From: [Rod Malcom](#)
To: [City of Poulsbo Planning and Economic Development](#)
Cc: [Nikole CH. Coleman](#)
Subject: RE: [External] Pinnacle at Liberty Bay PRD and Preliminary Subdivision - Technical Review No. 2
Date: Friday, December 19, 2025 11:39:04 AM
Attachments: [Pinnacle at Liberty Bay Technical Review 2.pdf](#)

Pinnacle at Liberty Bay PRD and Preliminary Subdivision - Technical Review No. 2

RE: Proposed Pinnacle at Liberty Bay PRD – Application of Poulsbo Municipal Code Section 18.260.070 Planned residential development site design criteria.

RE: Proposed Pinnacle at Liberty Bay PRD – Application of Poulsbo Municipal Code Section 18.260.070 Planned residential development site design criteria.

Fig 1. Site potential tree height at project site.

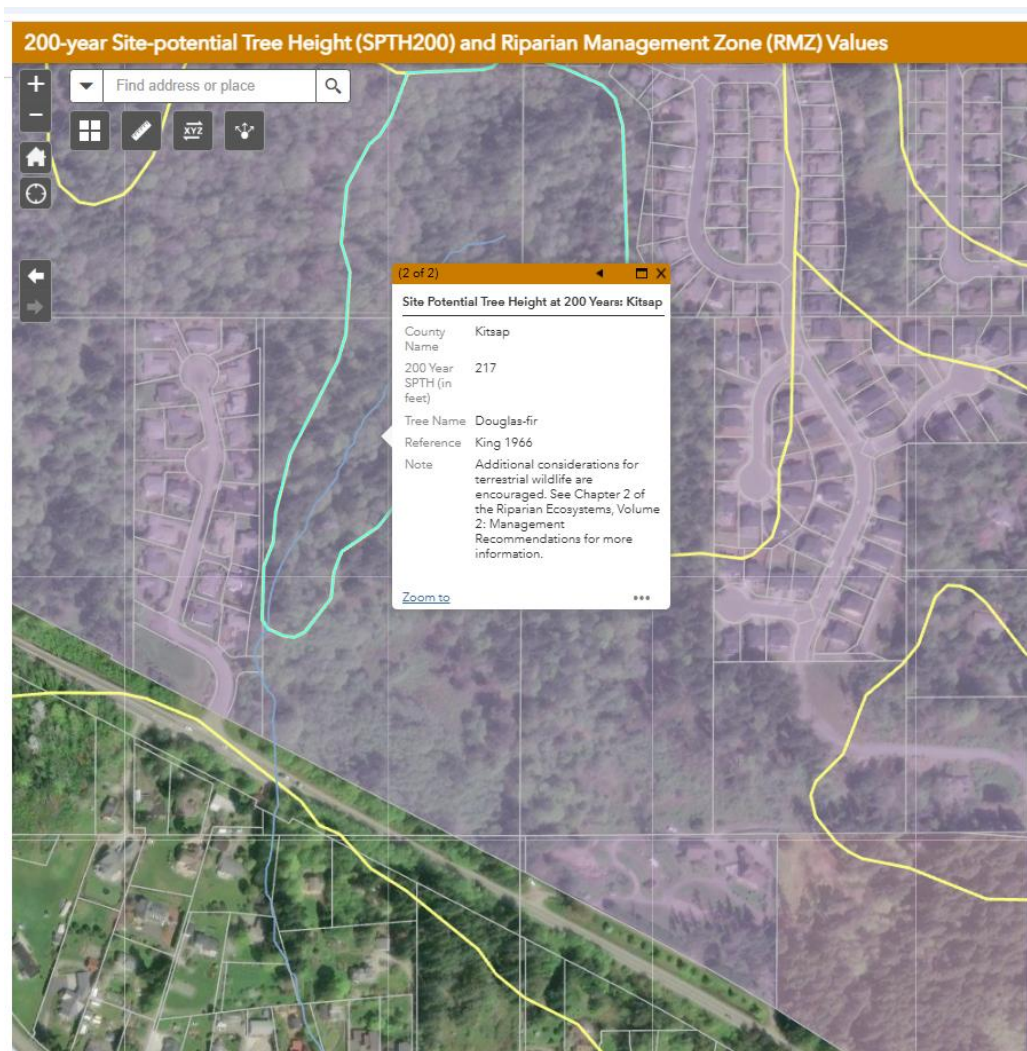
The applicant should not expect stream buffers less than the recommended minimum of 100 feet, will be sufficient to remove pollutants. Additionally, it should be assumed that any riparian buffer less than a SPTH is a *de facto* impact to the non-pollutant removal functions of the riparian area that should be considered during SEPA and other environmental review.

The stream buffers as proposed by the applicant do not meet Code requirements, let alone Best Available Science.

OFFSITE MAINTENANCE ROAD – PLAN & PROFILE

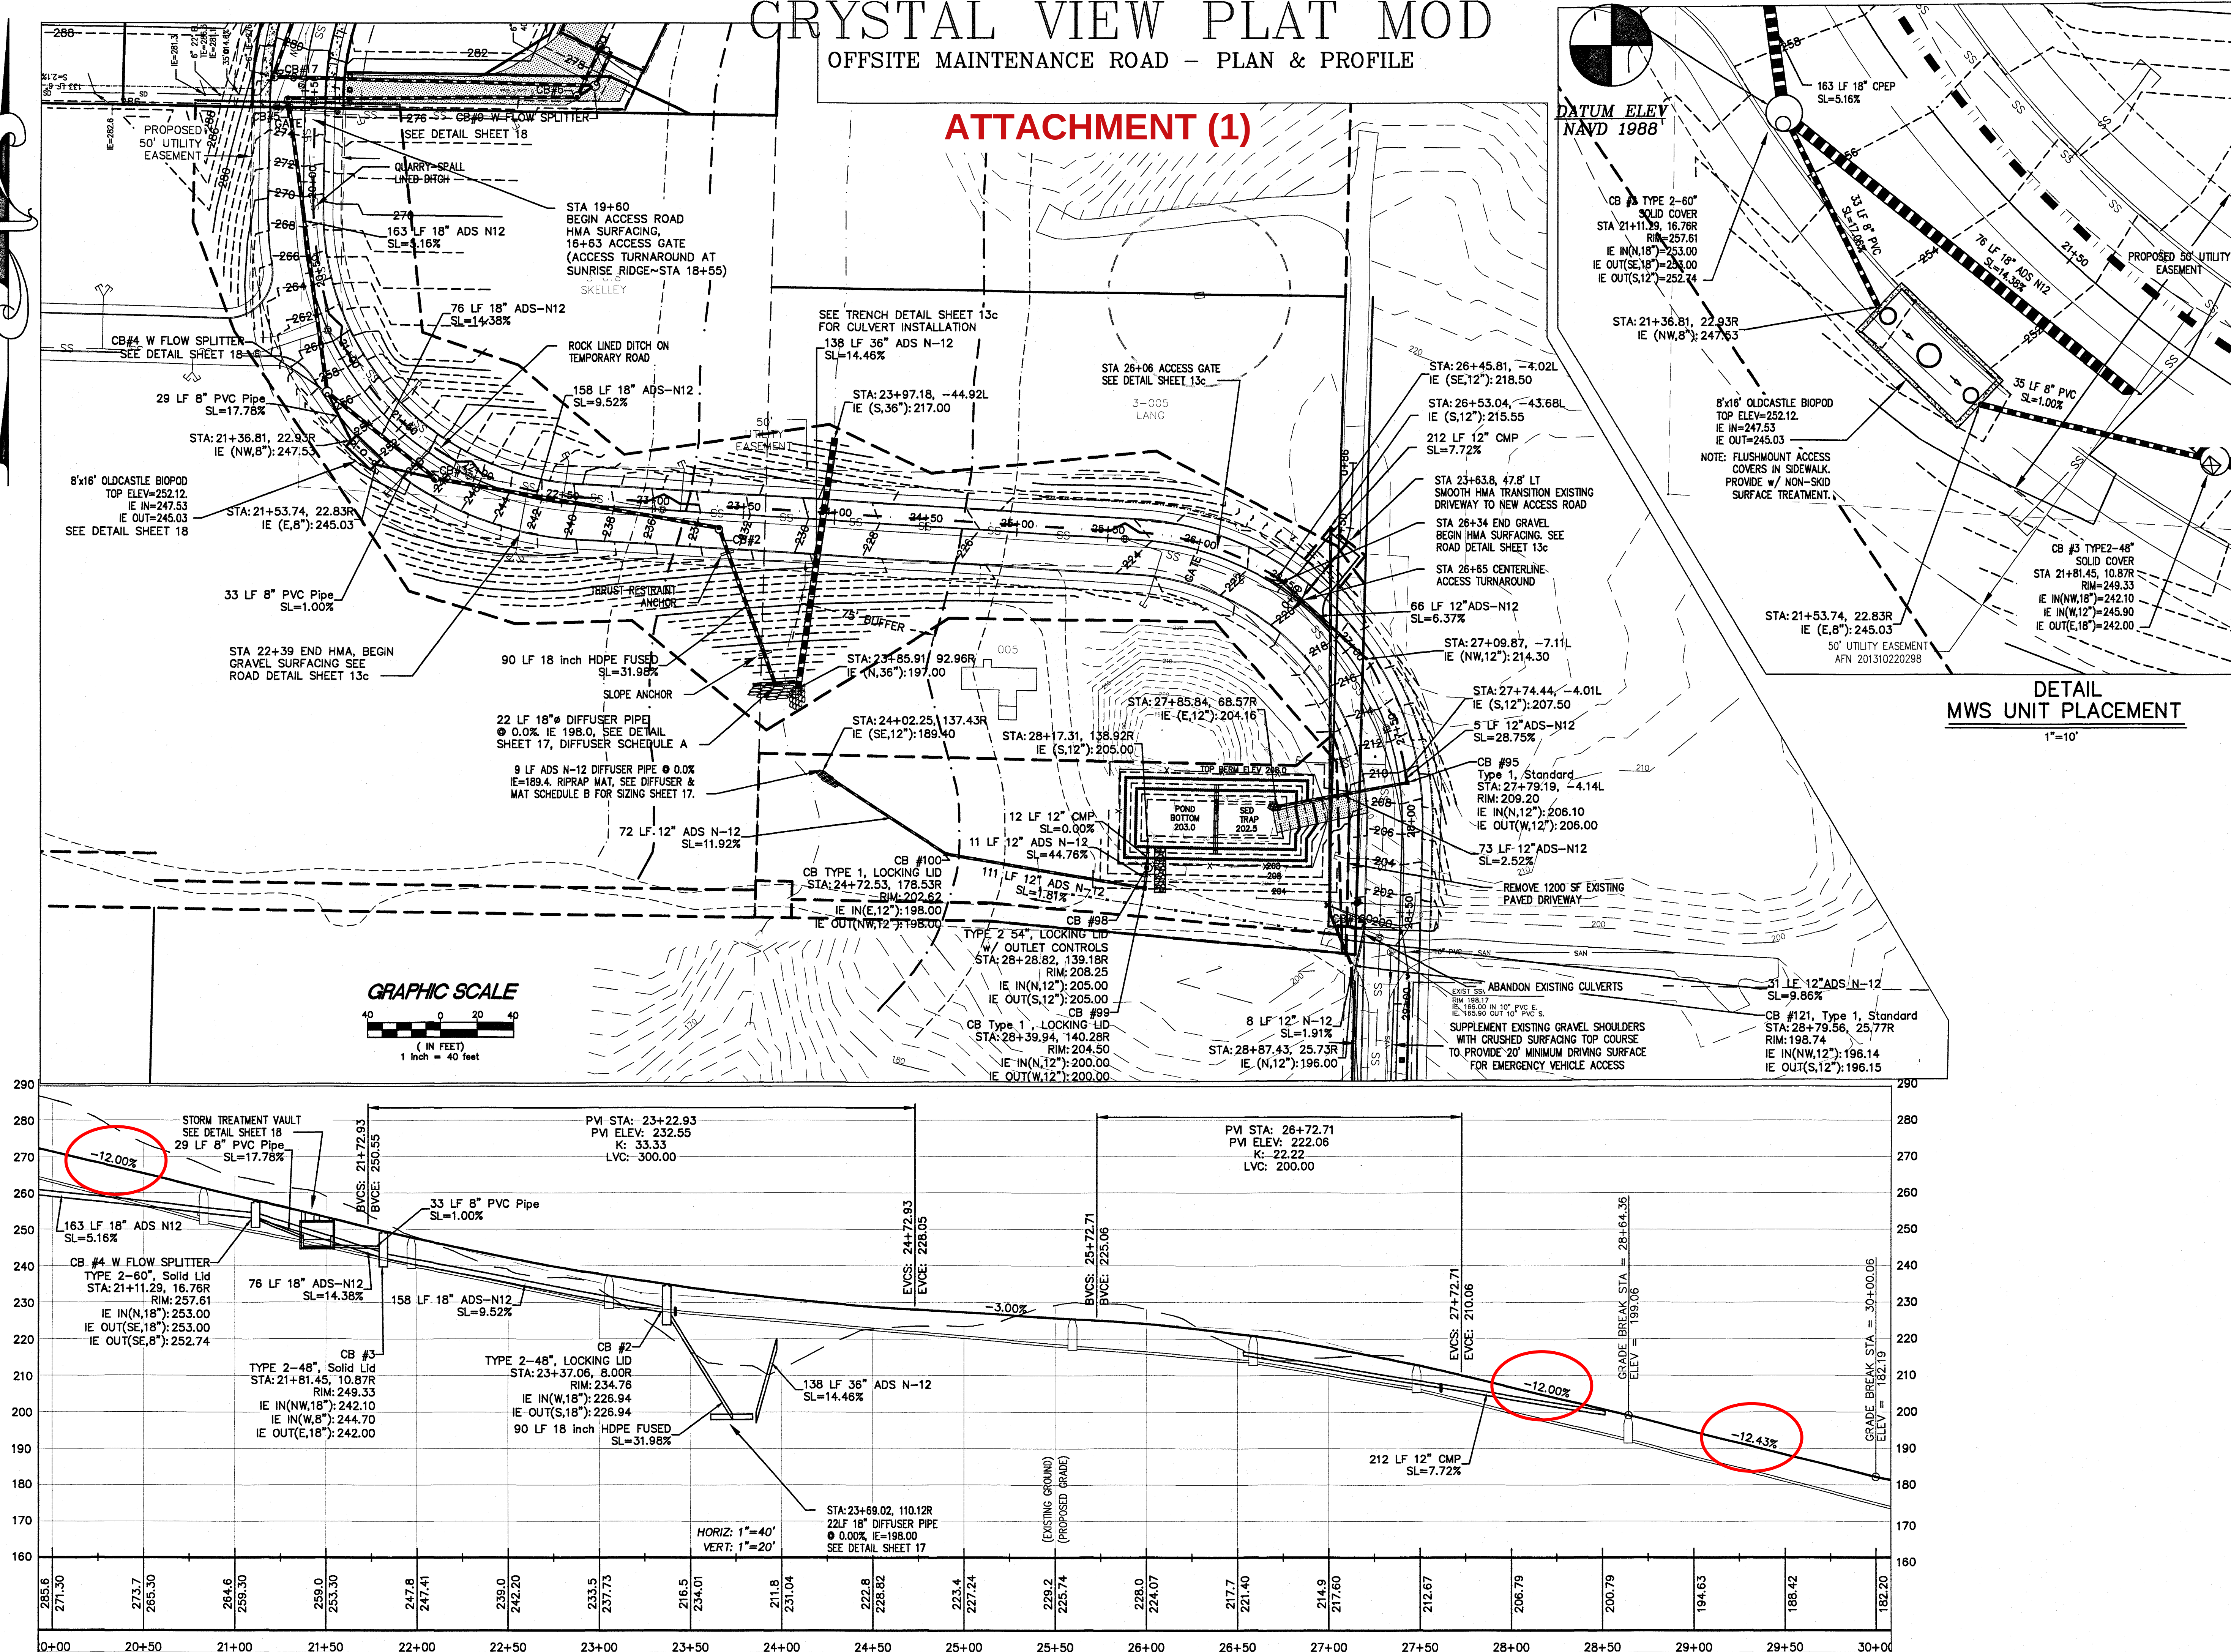
The Sunrise Ridge S-curve segment was constructed during the development of the Crystal View subdivision. As shown in the Crystal View Plat Mod drawing from 2016, (see Attachment 1) the S-curve is described as "Offsite Maintenance Road". The road segment appears originally to have been conceived primarily as a construction/service access route, a terrain-transition roadway, and a future connector segment.

Clarification is requested regarding whether the operational implications of this revised circulation structure were evaluated specifically with respect to the Sunrise Ridge corridor and the Road C intersection.

The Sunrise Ridge S-curve segment appears to combine several potentially challenging characteristics, including combined horizontal and vertical alignments, a short tangent section, and grades at or exceeding 12 percent, all as shown on the Attachment (1) drawing.
